DEVELOPMENT REVIEW BOARD

Parks and Recreation Department

PR-2021-006258
SI-2022-00057 – SITE PLAN
TIERRA WEST, LLC agent for BRUNACINI DEVELOPMENT LTD CO requests the aforementioned action(s) for all or a portion of: TRA-1-A A-2 A, JOURNAL CENTER PHASE 2, UNIT 2 zoned NR-BP, located on RUTLEDGE ST NE between RUTLEDGE RD NE and BARTLETT ST NE containing approximately 4.7483 acre(s). (D-16, D-17)
PROPERTY OWNERS: BRUNACINI DEVELOPMENT LTD CO
REQUEST: DRB SITE PLAN

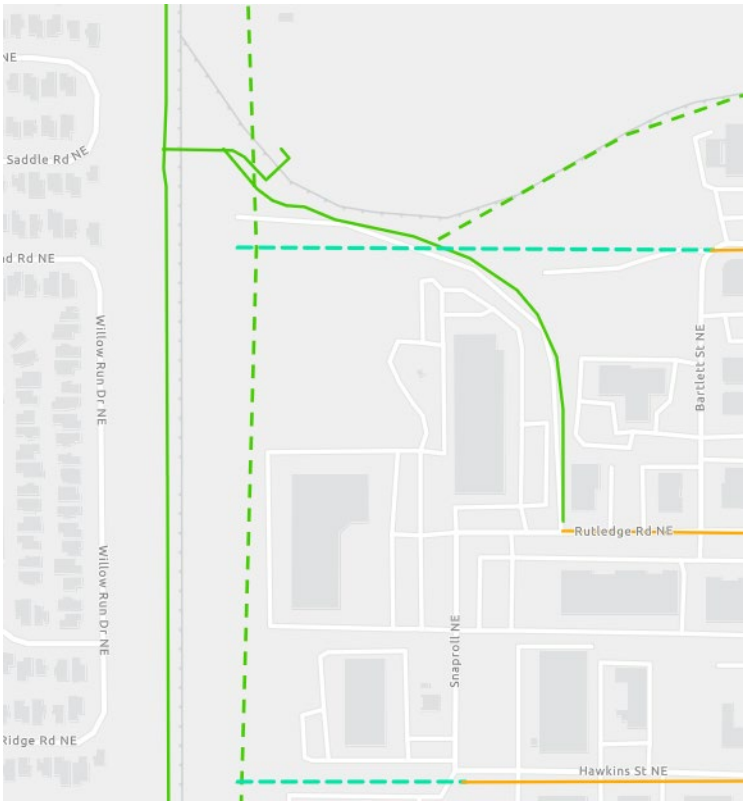
1. The MRCOG Long Range Bikeway Map shows a proposed multi-purpose trail on this side of the AMAFCA ROW (see screen clip below). This may need to be added to the required infrastructure on the west side of the property.

1. Have been communicating with applicant ex-parte regarding this issue. Have contacted DMD and MRCOG and still awaiting agency response to get this question resolved.
